**DEPARTMENT OF TRANSPORTATION  
STATE OF GEORGIA**

**FILE:** CSSTP-0006-00(857)(866) Paulding Cobb      **OFFICE:** Engineering Services  
P.I. Nos.: 0006857 & 0006866  
SR 92 from Cedarcrest Rd. To SR 3/US 41      **DATE:** September 14, 2009

**SUBJECT: IMPLEMENTATION OF VALUE ENGINEERING STUDY ALTERNATIVES**

**SUBJECT:** Value Engineering Study-Responses

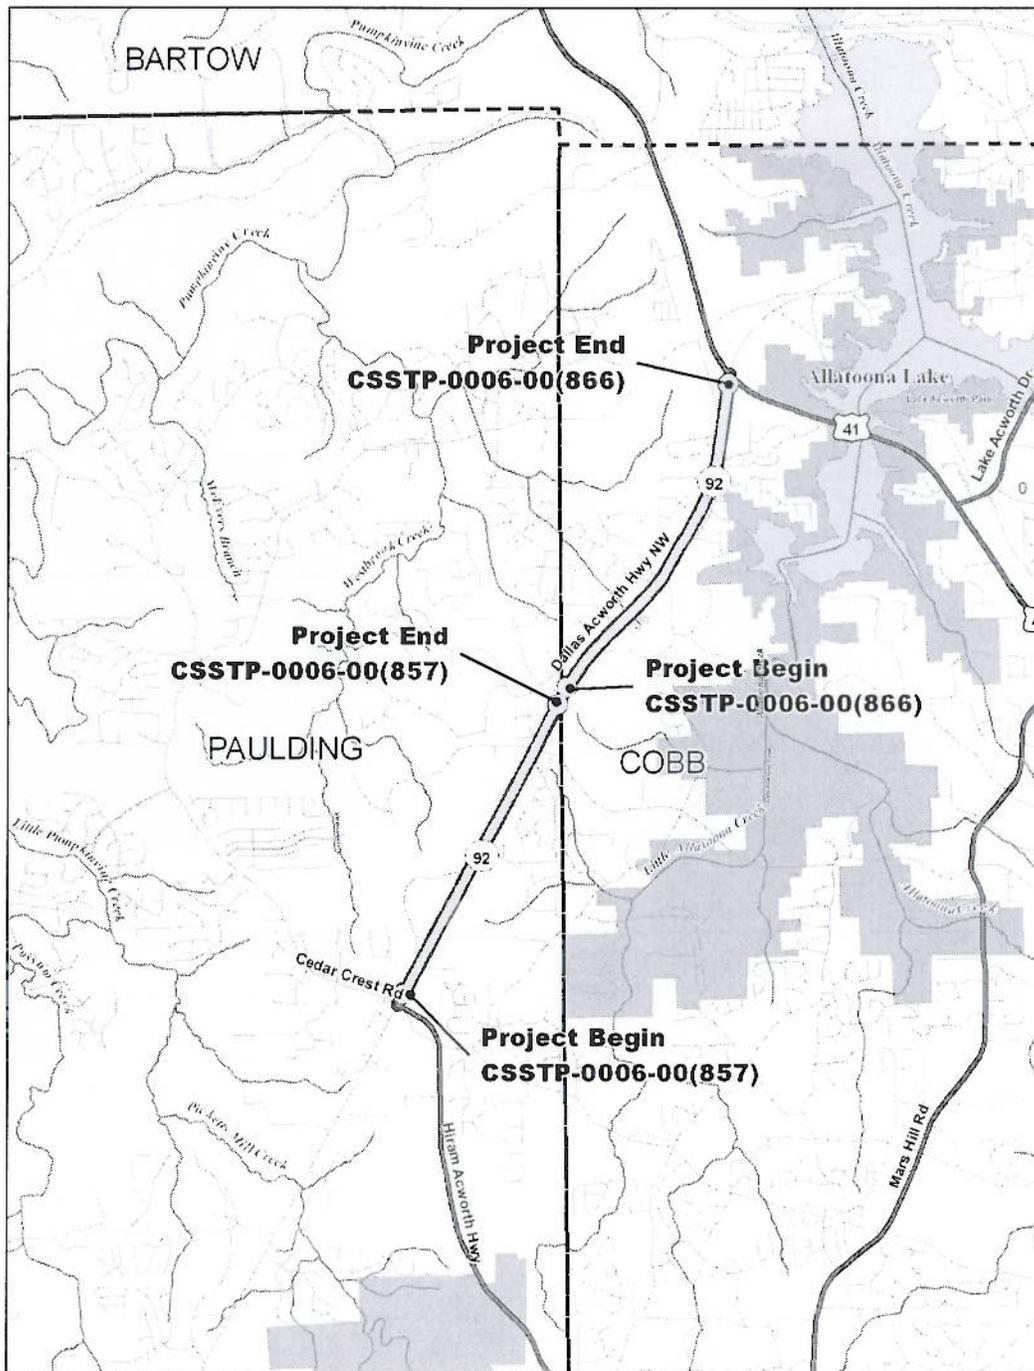
**10. Value Engineering Alternative No. RD-26:** Use 4" concrete in lieu of 6" or 8" concrete in the median. Approval of VE Study Alternative No. RD-26 is recommended except where the median is placed on existing asphalt.

- The median will be dowelled in on the existing asphalt. Where the median is dowelled in the curb is 6" high and therefore the median should be 6" to remain flush with the back of curb. The 6" median prevents standing water behind the curb in these areas. Where the median is not built on the existing pavement the median will be 4" concrete. At this time it is estimated the curb can be 4" for 50% of the proposed typical.
